Service Bulletin

NO. 1231

Subject: Changes to Eaton® Light Duty Hydrostatic Transaxles - Series 750, 850, 770, and 780.

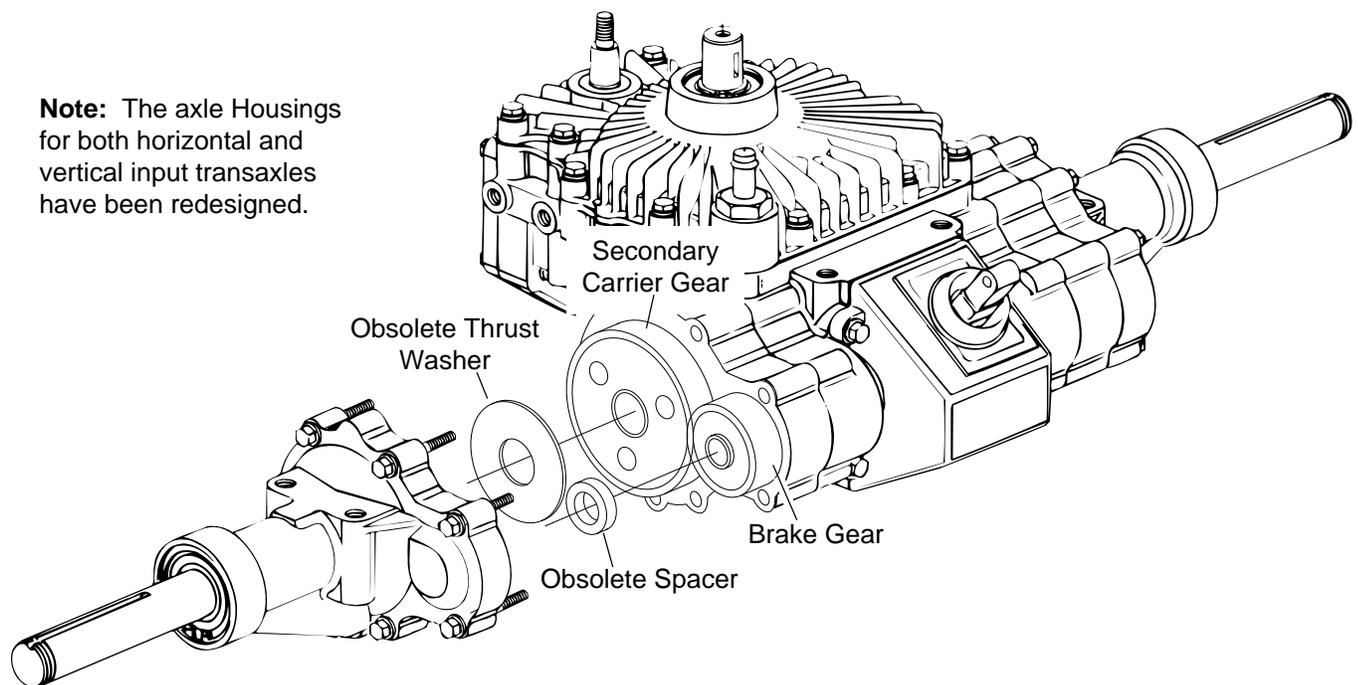
The axle housings on all Light Duty Hydrostatic Transaxles, Series 750, 850, 770, and 780, have been redesigned. The redesigned axle housings no longer require the thrust washer or spacer, see drawing below.

Note: The axle Housings for both horizontal and vertical input transaxles have been redesigned.

The thrust washers, spacers, and old style axle housings are no longer available. If any of these parts need to be replaced you must install the new style axle housing.

This change became effective July 1, 1989. Units manufactured after the change will have a date code of G01J or higher. The parts lists for these transaxles (form numbers 6-412, 6-413, 6-416, and 6-417) have been revised and are dated November, 1989.
